Shovon Knitwear Ltd. (10922)

West Masdair, Fatullah, Narayanganj

Identified Priority 2 Concerns

1st Priority 2 Concern

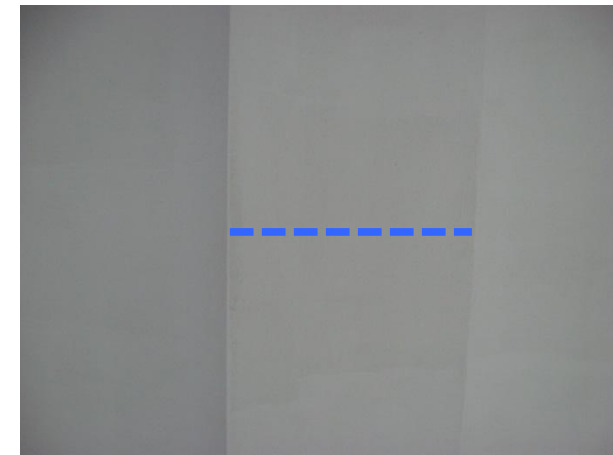
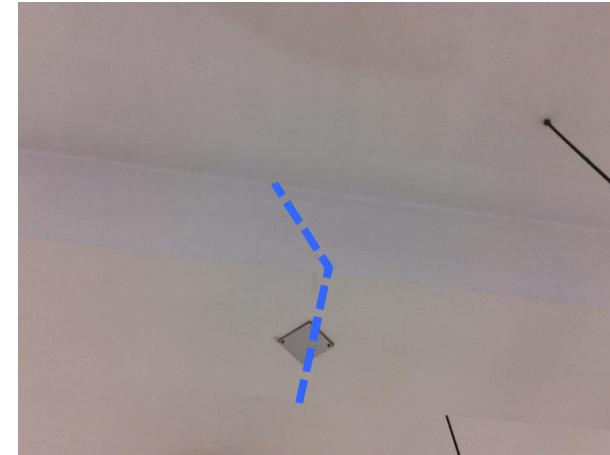
Cracks on 4th floor beam.

Several cracks found on 4th floor beams spanning approx. 8.50m. We were informed that structural elements in this building were covered with plasterwork. It is not clear if these cracks are structural. They should be investigated further.

- The Factory Engineer to investigate the cause of cracks by appropriate methods.
- The distress found is to be suitably rectified and then repaired.

Overall stability system / moment frame capacity

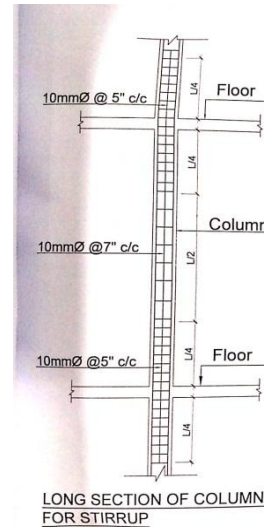
It is appeared that the original Engineer was aware of lateral loads. However, there is no evidence that a lateral stability system had been used. Therefore, we require that these items are investigated as part of a Detailed Engineering Assessment .

- Request that the Detailed Engineering Assessment of overall building to be carried out again with the actual built conditions.
